How the Inspector was misled about the height.

Paragraph by paragraph exposé.

Detail taken from an unauthorised drawing retrieved from the Council Archive in September 2013.

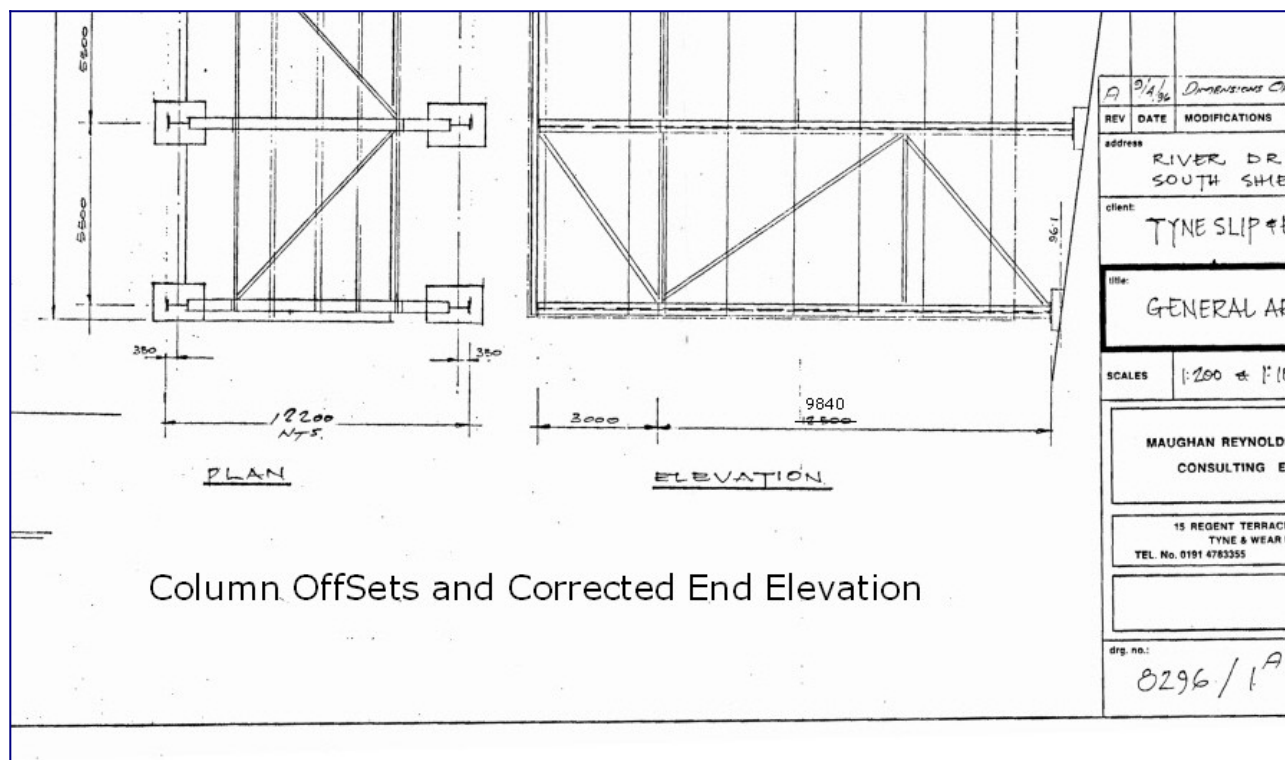
There are numerous ways to arrive the correction for the landward elevation which is given as $12500 + 3000$. The easiest is to look at an approved print which give the dimension as $108.8 - 96.1$ or 12.7m

Authorisation stamp of the T&WDC – 8296/2 in the Council's possession.

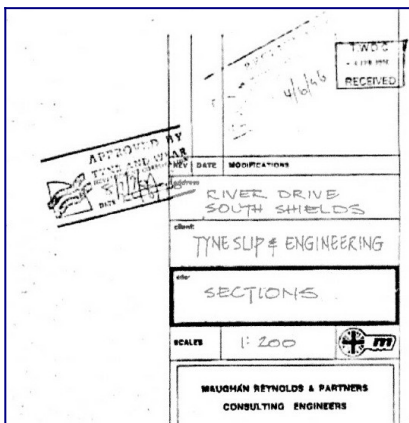
30. Mr X says the shed is also 3 metres higher than shown in the 1996 plans. He says a scale measurement from the plans shows a total height of 12.75 metres at one end of the shed. – [*this is true and for confirmation see 8296/2 which gives an authorised height of 12.7m.*](#)

-see #30 or 33. 1B and 1A are interchangeable, both show the same error and neither have been authorised, contrary to what the senior planning officer has told the Local Government Ombudsman.

** there is no indication on this drawing that it has ever been to the Tyne and Wear Development Corporation.*
